# CECIL COUNTY PUBLIC SCHOOLS PURCHASING DEPARTMENT

## CCPS RFP # 24-06 – Cecil County School of Technology Chiller Replacement Project

### ADDENDUM #2

1  
M2.1  
MECHANICAL ROOM PART PLAN - NEW WORK  
SCALE: 1/4" = 1'-0"

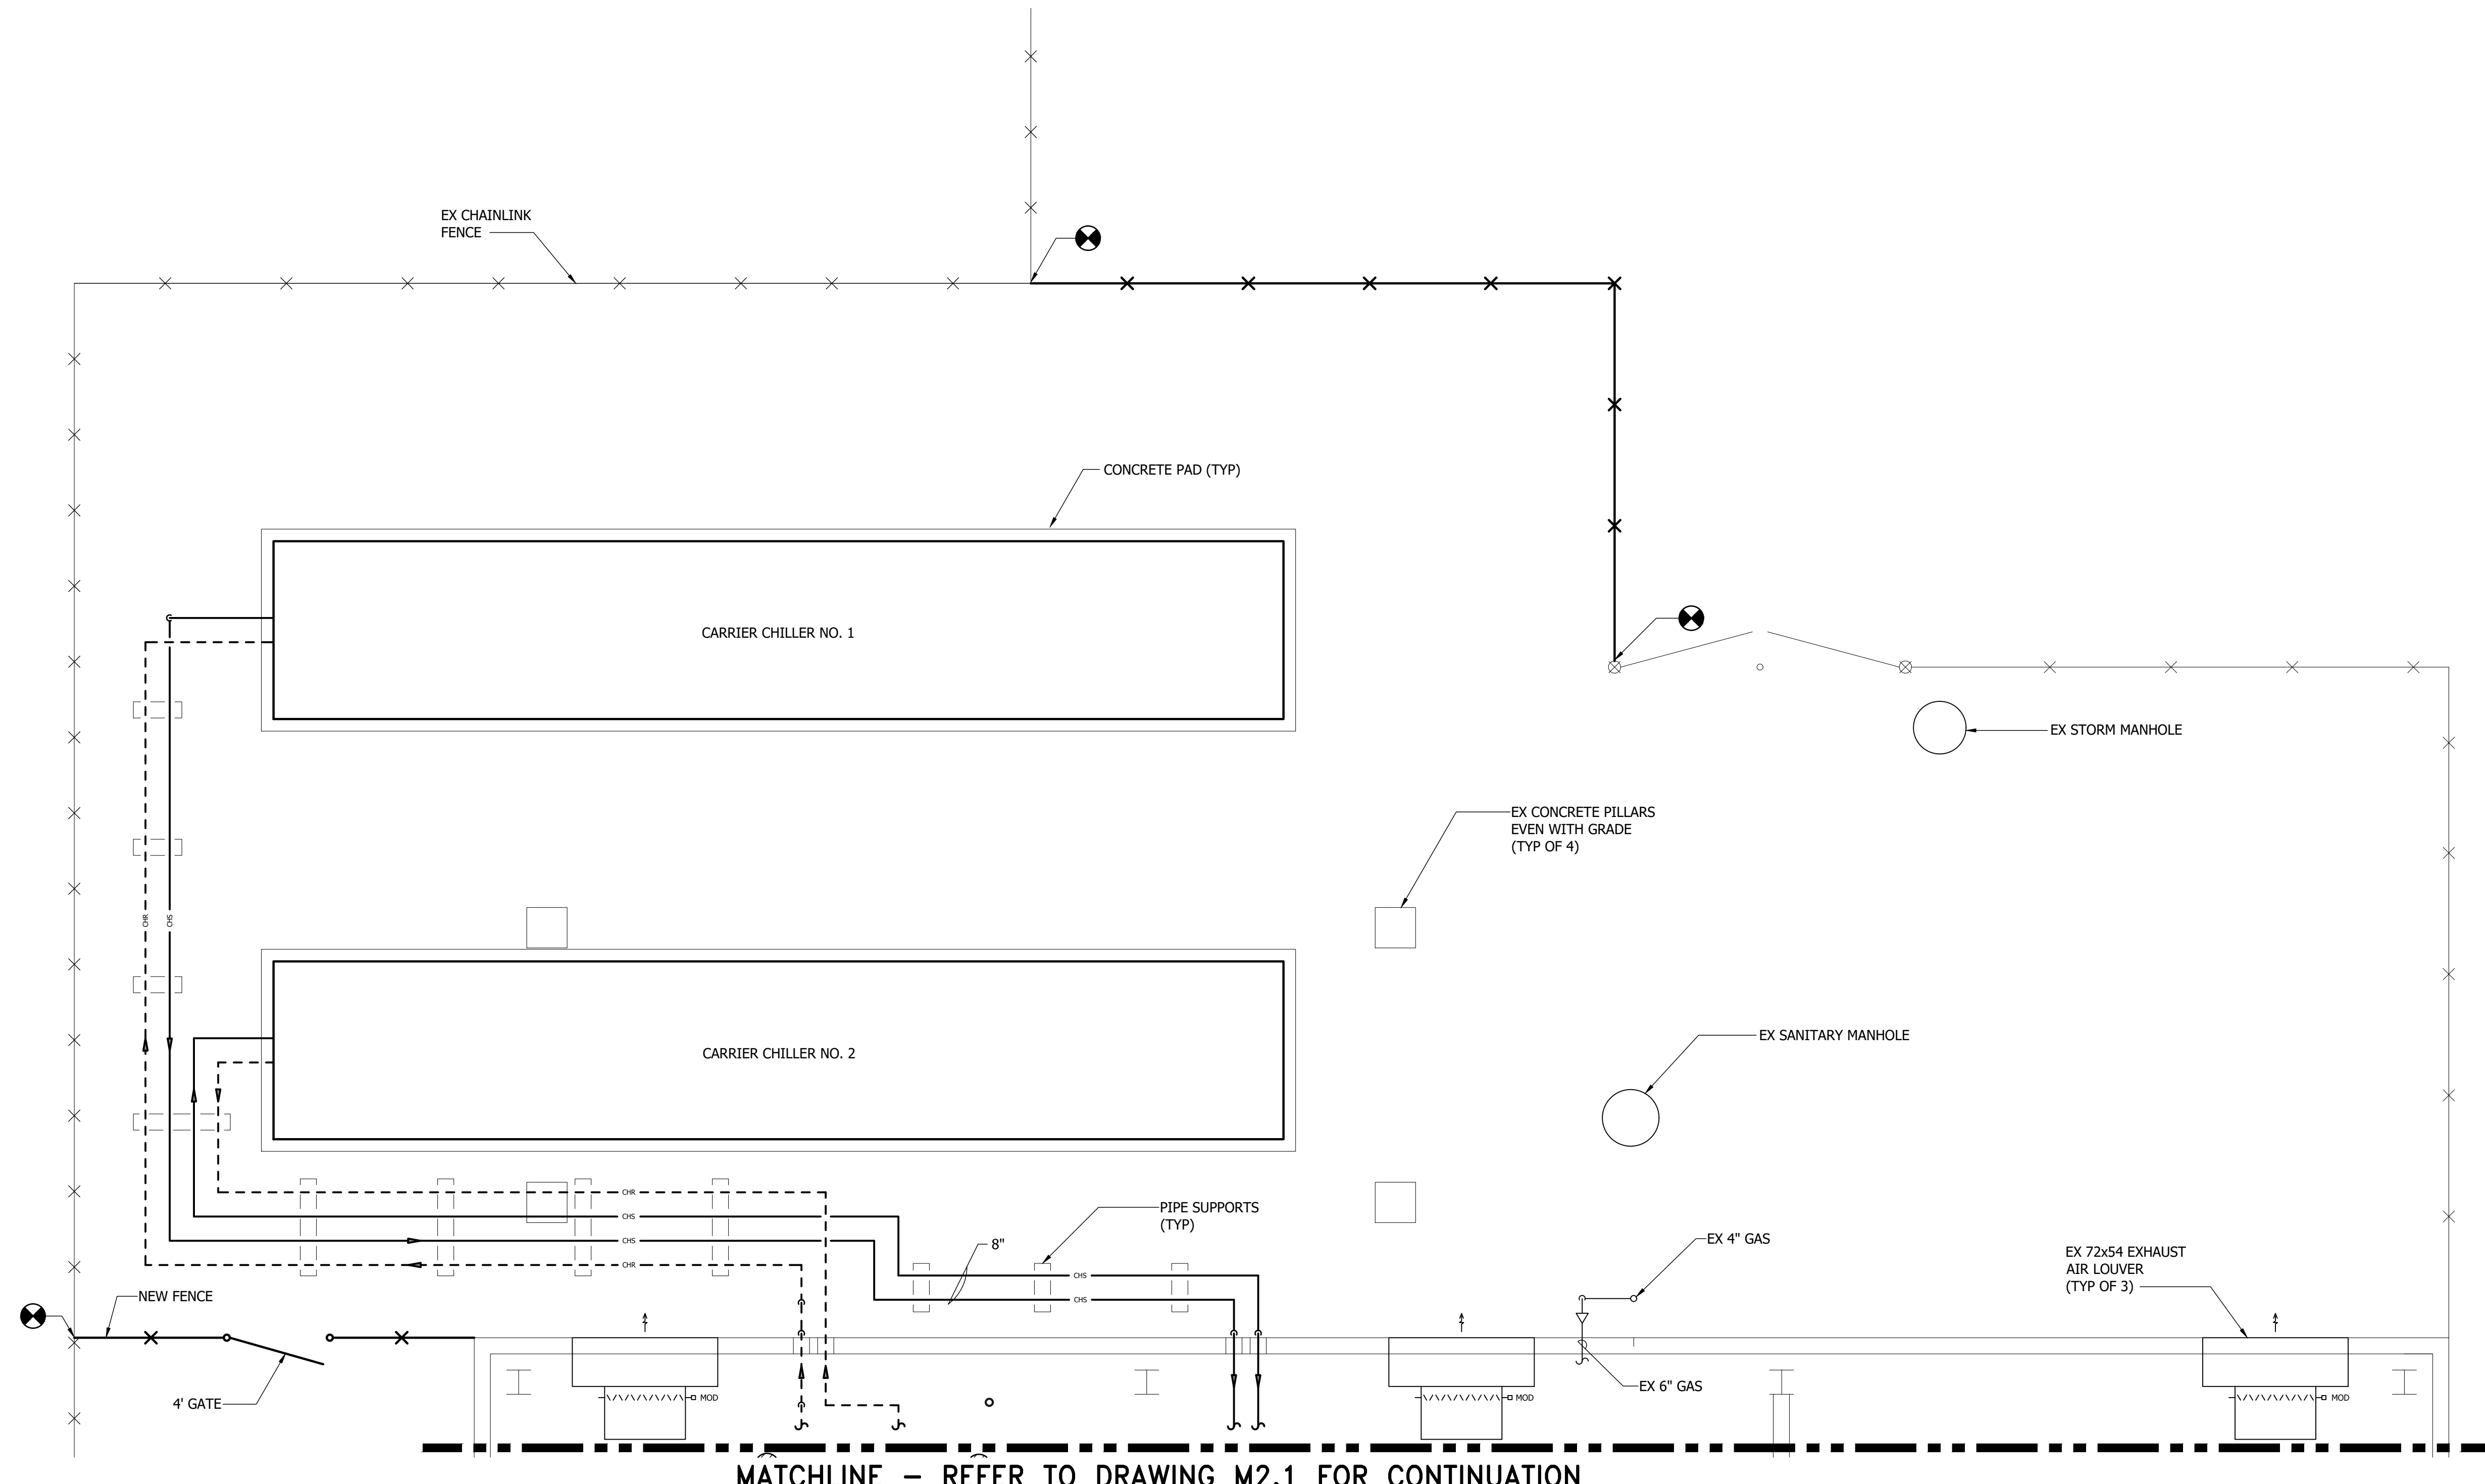
**ITEM No. 4   REVISE: DRAWING M2.2 MECHANICAL ROOM PART PLAN – NEW WORK**

- Revised Drawing 1 to clarify pumps under Alternate no. 1.

**QUESTION 1:** Please confirm Drawing [M2.2] should be labeled New Work and not Demolition.

**ANSWER 1:** Should be labeled New Work.

COURTYARD PART PLAN - NEW WORK

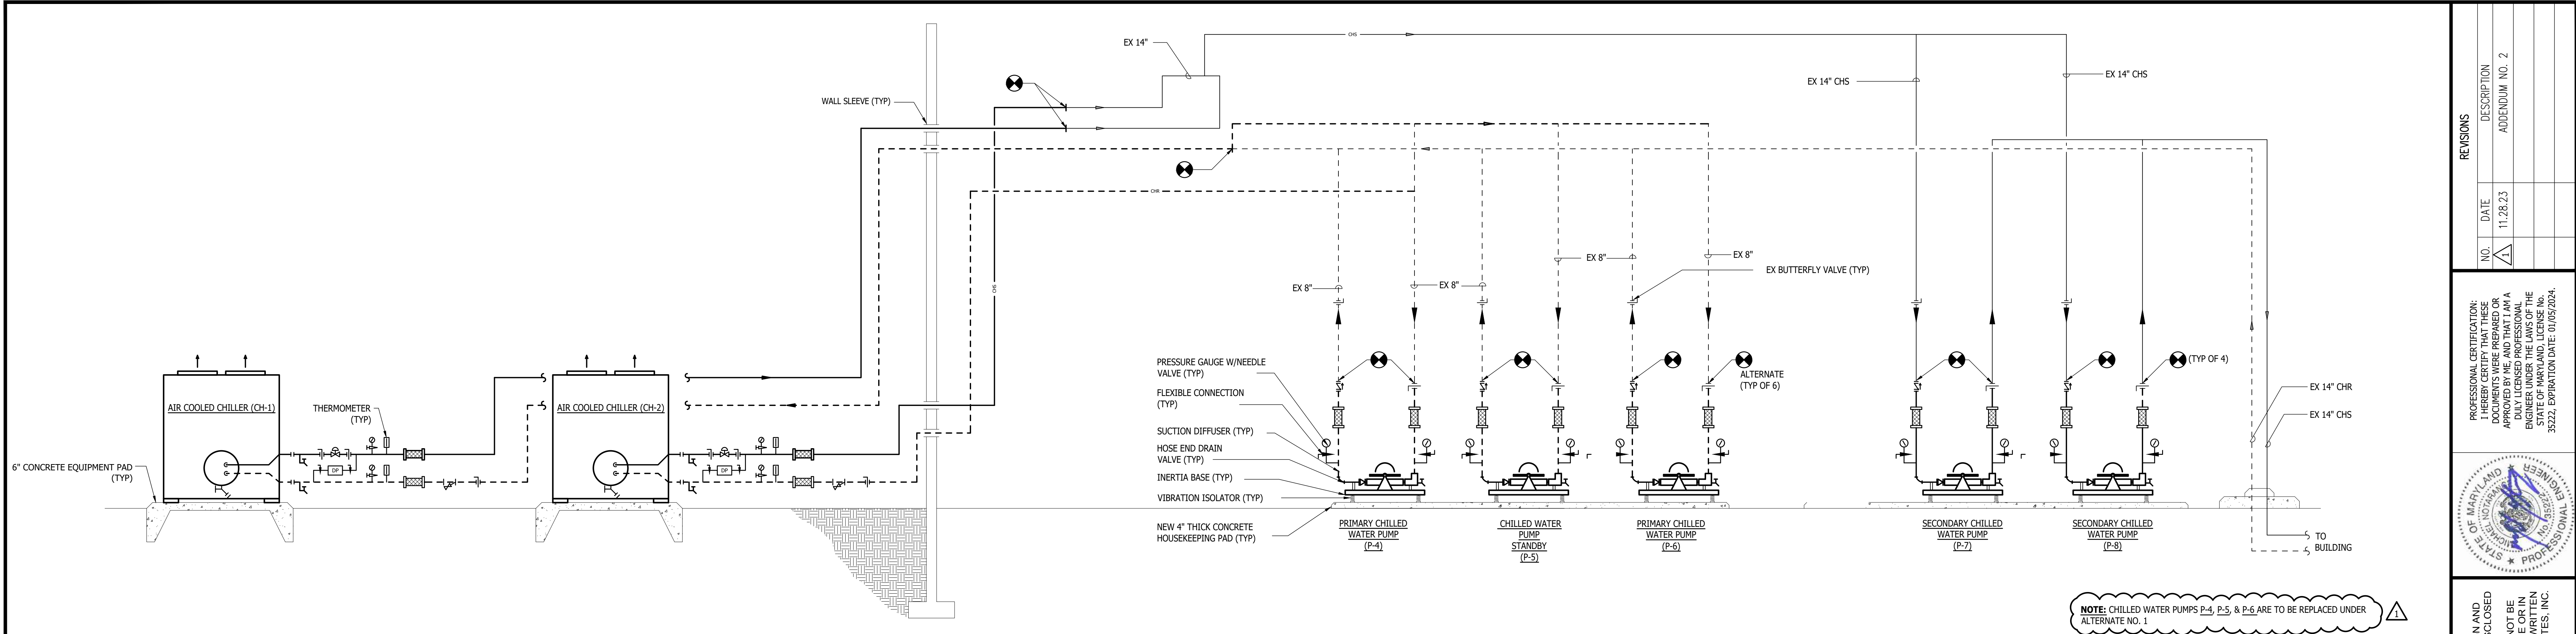
**ITEM No. 3   REVISE: DRAWING M2.1 COURTYARD PART PLAN – NEW WORK**

- Revised Drawing 1 to reflect correct title “Courtyard Part Plan – New Work”.

1 CHILLED WATER SYSTEM PIPING SCHEMATIC

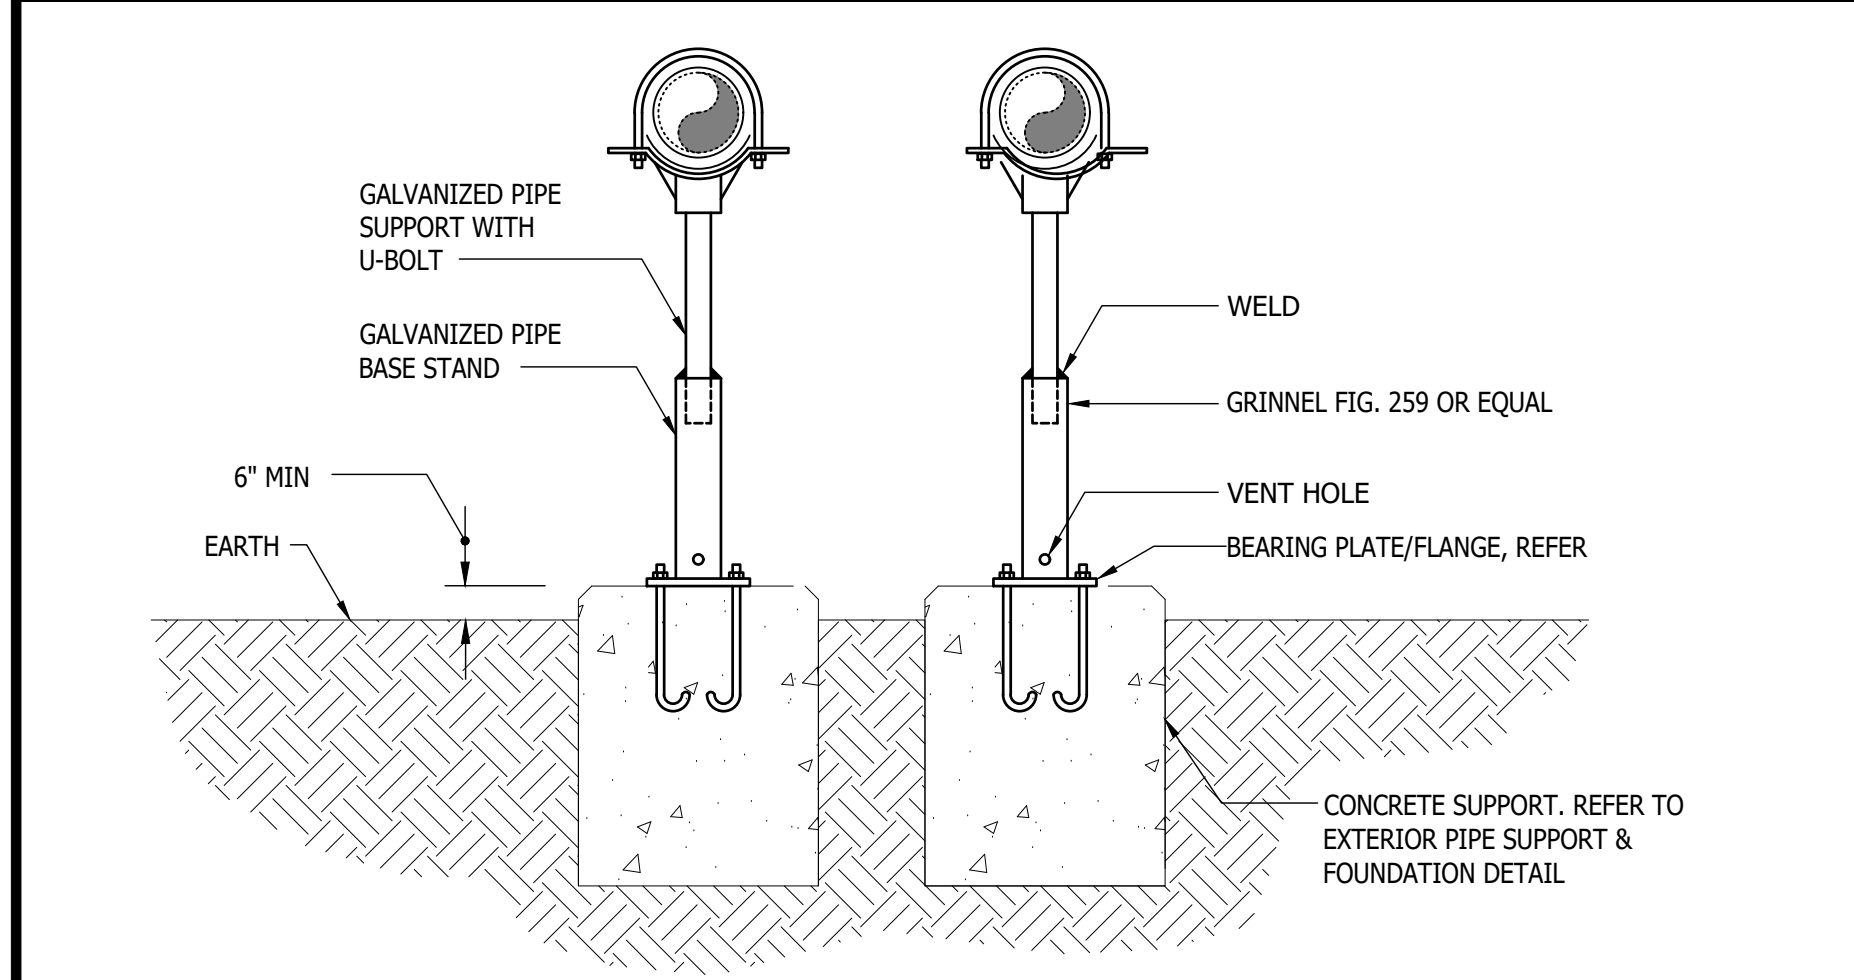
**ITEM No. 5   REVISE: DRAWING M4.1 MECHANICAL DETAILS**

- Revised Detail 1 note to include pumps under alternate.

**QUESTION 2:** Please clarify. Specifications [012300] does not list any alternates, but Drawing [M4.1 detail 1] notes ‘Chilled water pumps are to be replaced under alternate’. Is this alternate solely the replacement of P-4, P-5, and P-6?

**QUESTION 11:** On drawing M4.1 it states to provide alternate pricing for the chill water pumps. The bid form did not have any alternates listed. Are we to provide the pumps as an Alternate? Are there any other alternates?

**ANSWER 2:** Primary chilled water pumps are to be replaced under Alternate No. 1.

**ANSWER 11:** Replacing the chilled water pumps is included under Alternate No. 1.

1  
E2.1  
MECHANICAL ROOM PART PLAN - ELECTRICAL NEW WORK  
SCALE: 1/4" = 1'-0"

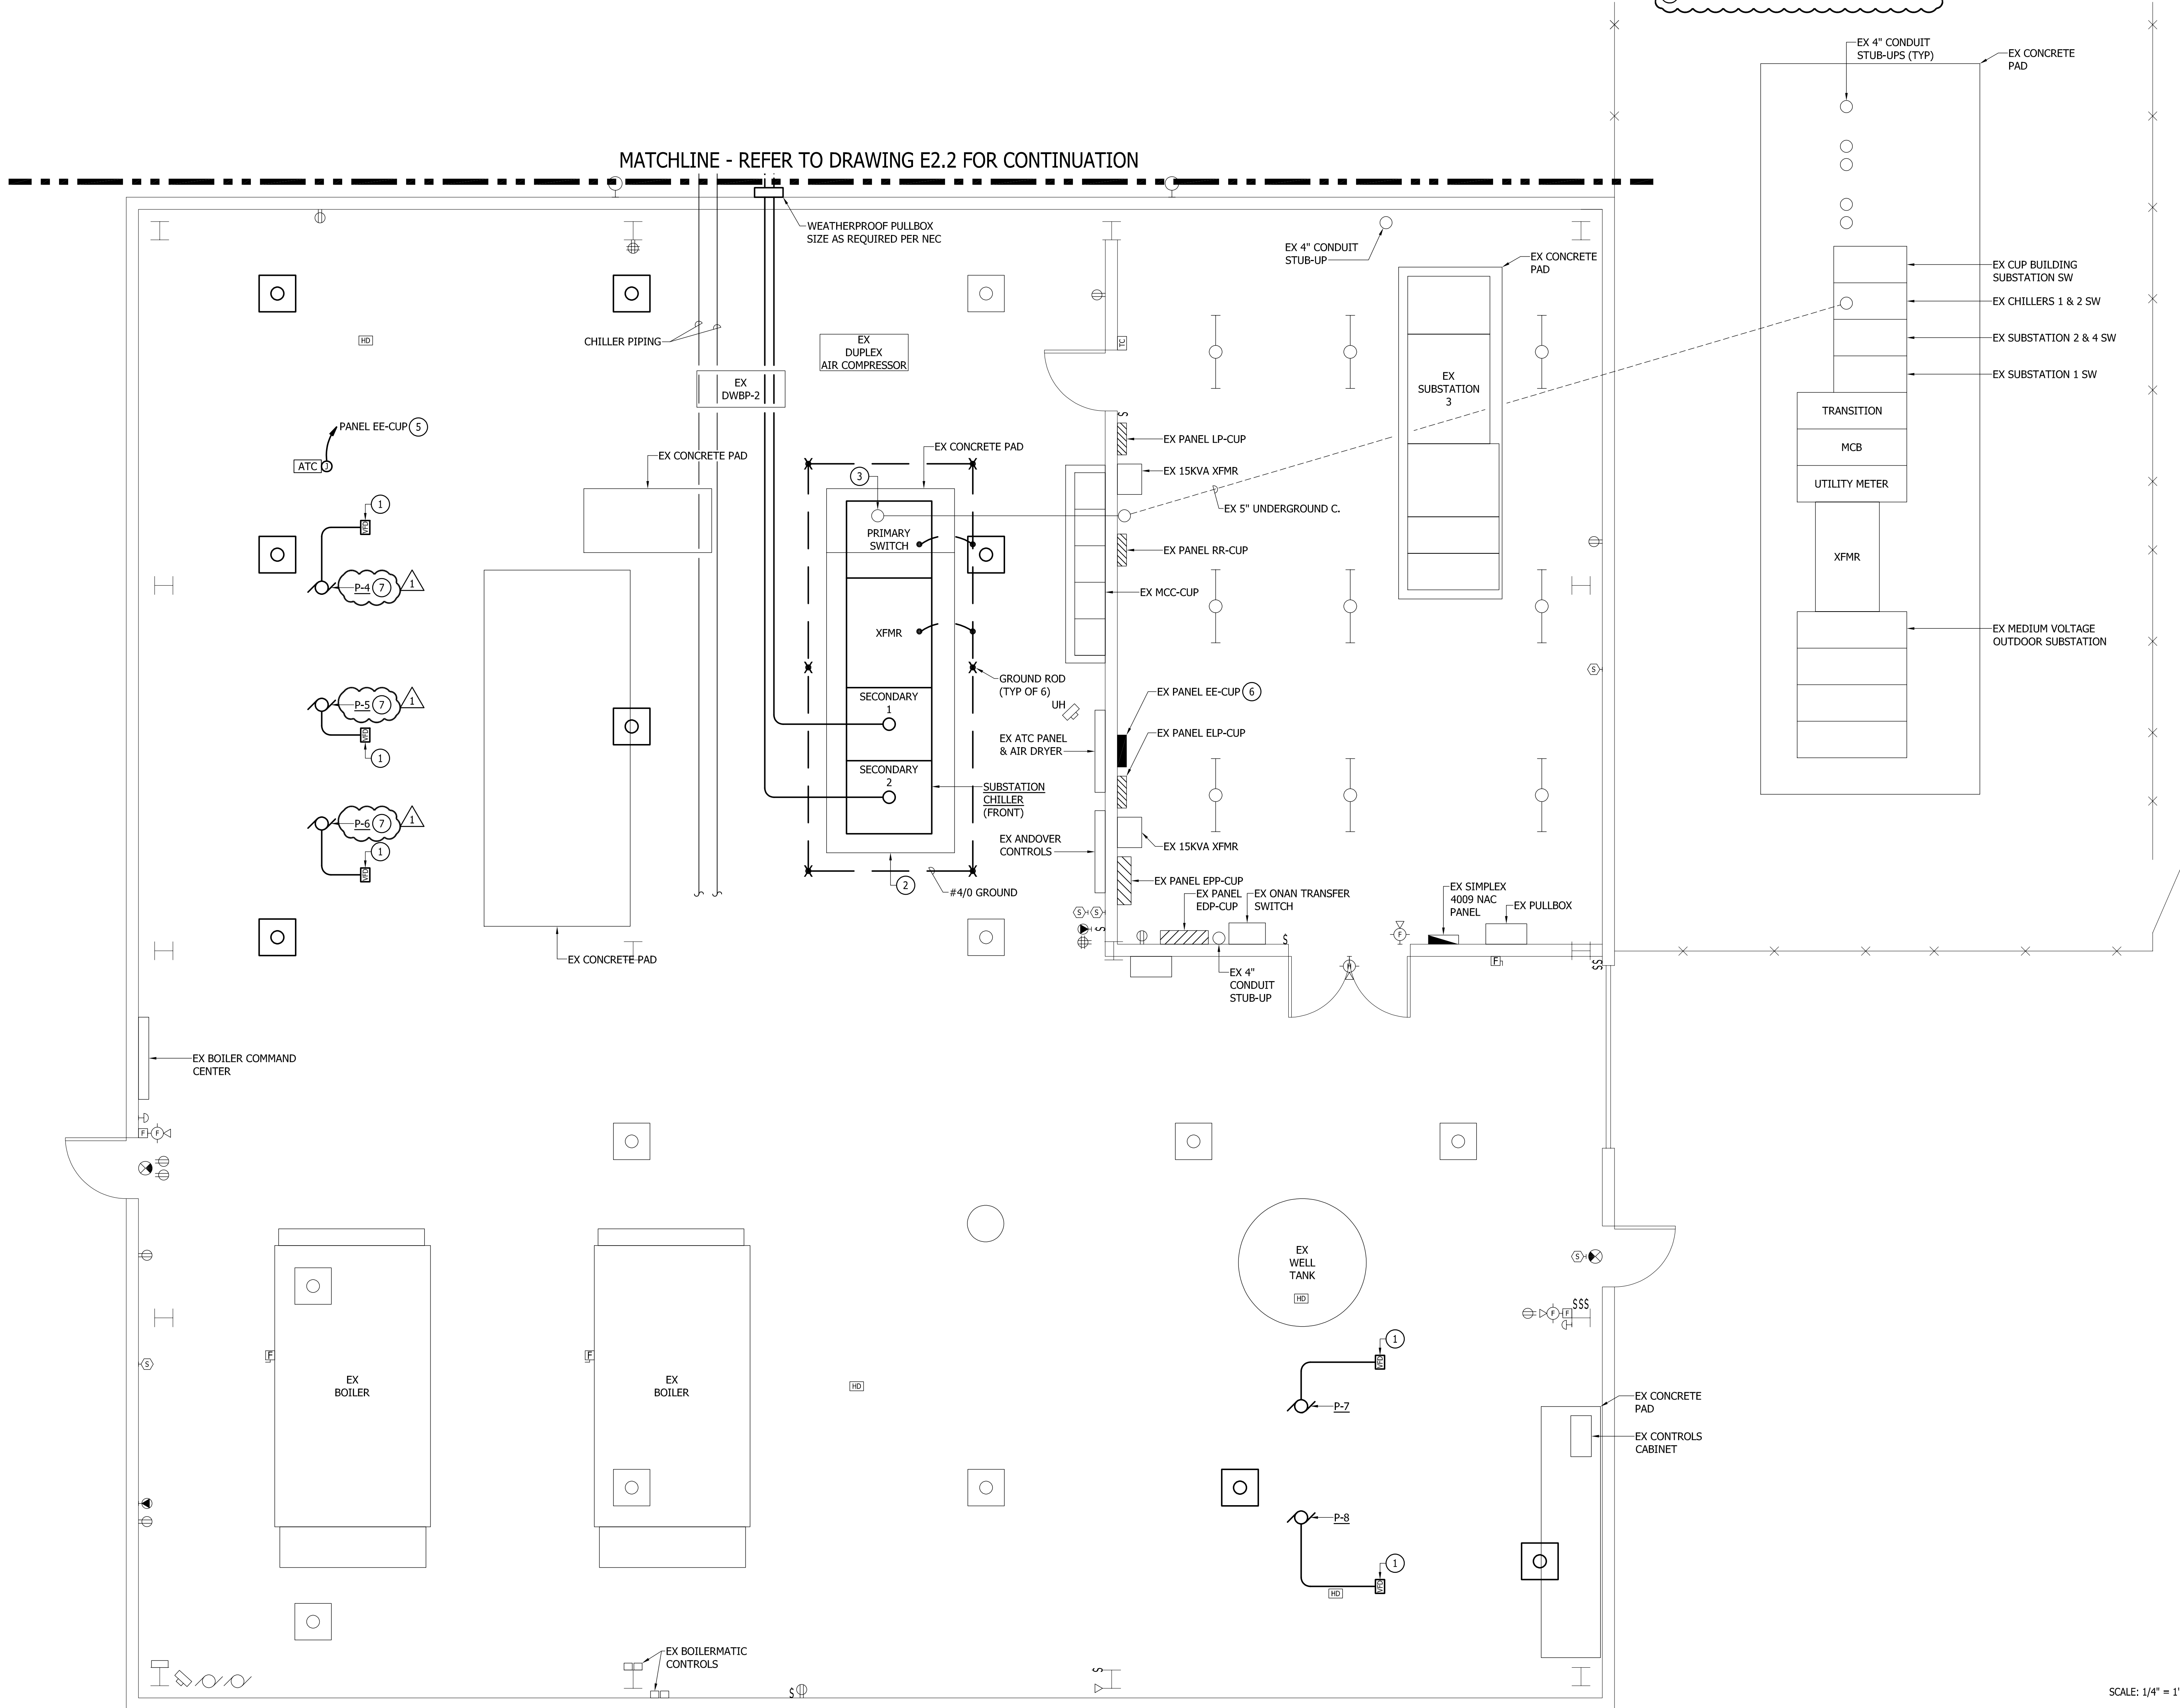
**ITEM No. 8   REVISE: DRAWING E2.1 MECHANICAL ROOM PART PLAN – ELECTRICAL NEW WORK**

- Add Note indicating pumps P-4, P-5, & P-6 are included in Alternate no. 1.

- PROVIDE KINDORF SUPPORTS AS REQUIRED.
- MODIFY AND EXTEND CONCRETE PAD TO SUIT THE INSTALLATION OF THE SUBSTATION.
- COORDINATE SWITCHGEAR PLACEMENT WITH EXISTING INCOMING PRIMARY FEEDER. EXTEND CONDUITS AS REQUIRED.
- PROVIDE 2 #12 AND 1 #12 GROUND IN 3/4" CONDUIT AS REQUIRED AND MAKE ALL CONNECTIONS TO NEAREST EXTERIOR RECEPTACLE.
- 2 #12 AND 1 #12 GROUND IN 3/4" CONDUIT TO SPARE CIRCUIT BREAKER IN EXISTING PANEL EE-CUP.
- PROVIDE 1P, 20A CIRCUIT BREAKER IN EXISTING SQUARE D NQOD PANELBOARD.
- PUMPS P-4, P-5 & P-6 SHALL BE UNDER ALTERNATE NO. 1.
